WBN-TS-03-12

WATTS BAR NUCLEAR PLANT (WBN) – LICENSE AMENDMENT (WBN-TS-03-12)  
MONITORING OF CONTROL OR SHUTDOWN ROD POSITION BY AN ALTERNATE  
MEANS - REQUEST FOR ADDITIONAL INFORMATION (RAI) (TAC MC 1419)

**PROPOSED LICENSE AMENDMENT REQUEST WBN-TS-03-12  
RESPONSE TO NRC'S REQUEST FOR ADDITIONAL INFORMATION**

**Figure 1  
Example of Wiring for the Monitoring of Gripper Coil Parameters  
Example Based on Control Rod E-5**

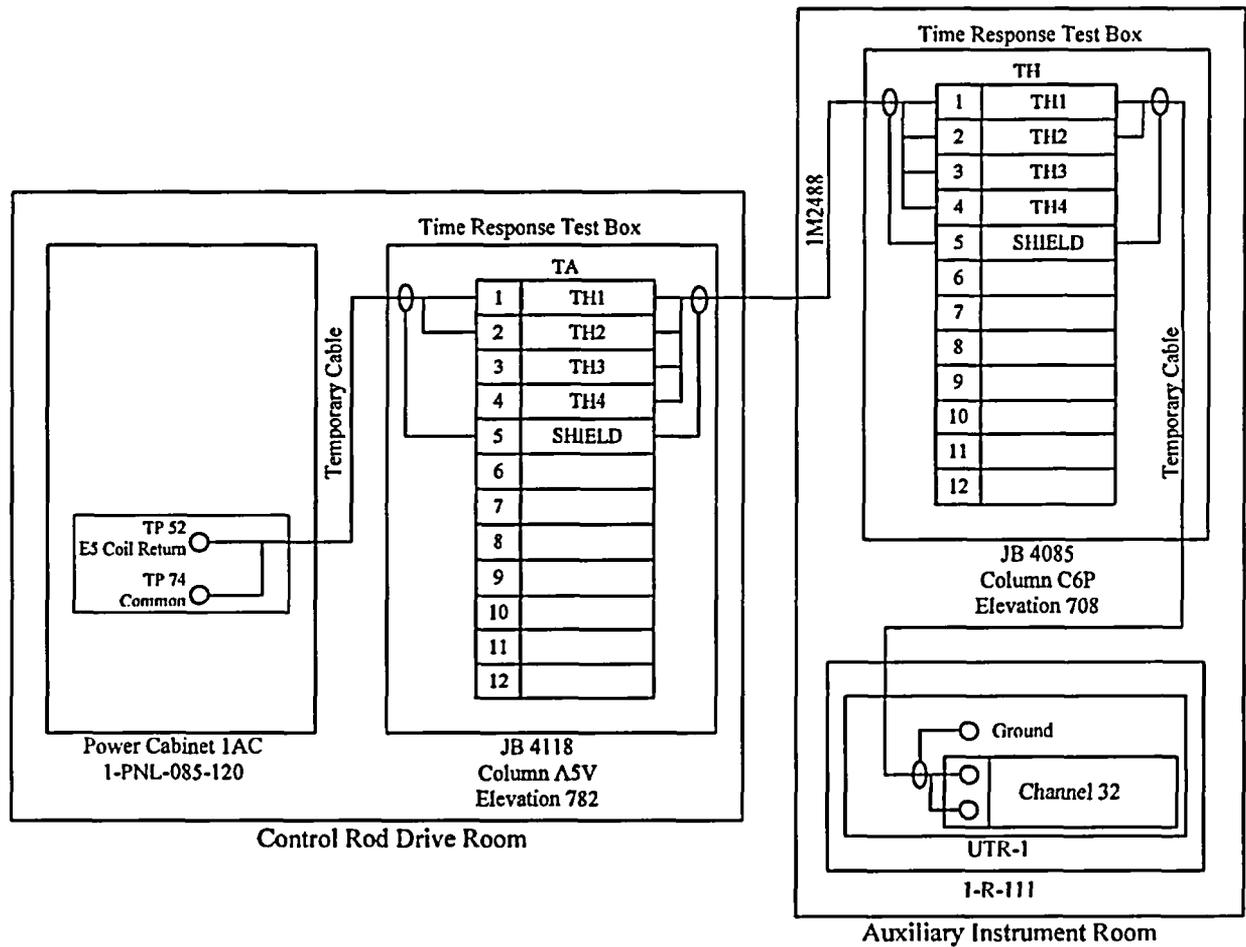
**NRC Question 1.a.1:**

A detailed description of the alternate method, including components relied upon in the alternate monitoring method.

**TVA's Response to Question 1.a.1:**

The following figure is an example of the wiring for the monitoring of the gripper coil parameters and is based on Control Rod E-5. The wiring for a different rod will terminate at different test points and/or a different power cabinet, but the remainder of the figure is essentially the same:

The proposed alternate monitoring method continuously samples current flow to the stationary gripper coil for the rod with the non-functional ARPI. This is accomplished through permanently installed test points in the control rod drive mechanism's associated power cabinet (1-PNL-085-120). The current is converted to a low level voltage signal via a permanently installed 0.0625 ohm, 50W resistor inside the power cabinet. Temporary cabling transfers the low level signal from the test points (one test point for the current and one test point for a ground reference) in the power cabinet to a time response test box [Junction Box (JB) 4118]. 1-PNL-085-120 and JB 4118 are located in the Control Rod Drive Room.

Permanent cabling (1M2488) then transmits the signal from the time response test box (JB 4118) to a time response test box (JB 4085) in the Auxiliary Instrument Room. Temporary cabling transmits the signal from the time response test box (JB 4085) to an electronics rack (1-R-111) that provides an interface with the plant computer. The plant computer digitizes the analog input and uses the input to determine if current is being applied to the stationary gripper for the affected rod (a non-zero signal) or if the gripper is de-energized (a zero signal). Additional detail on the software's evaluation of the stationary gripper parameters is provided in TVA's response to Part 1.a.3 of Question 1. In addition, the plant computer provides an output signal representative of rod position in steps to a digital recorder located on a control board (1-M-5) in the Main Control Room (MCR). This MCR board is adjacent to the control board (1-M-4) where the displays for the ARPIs are located.
